SUNDRY NOTICES AND REPORTS ON WELLS

CHI Operating, Inc. is planning to Plug and Abandon the Wallace State 4H well, procedure & wellbore attached.

Wallace State No. 4H

Plug and Abandon

Wallace State 4H

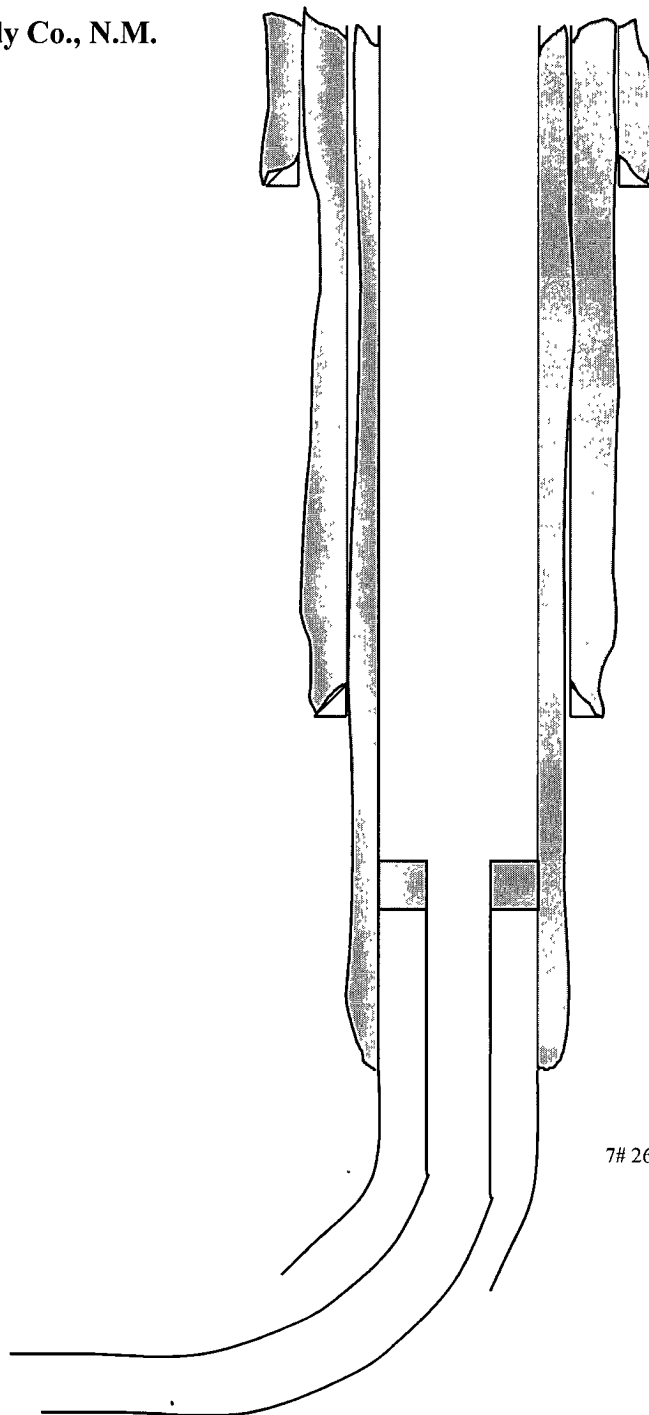
* 100' cement Plug @ 3391'

* 100' cement Plug @ 348'-448' w/o Tag.

60' cmt surface Plg.

100' cmt Plg - 348' - 448'

WOC TAG

Approval Granted providing work
is complete by 7/20/2010
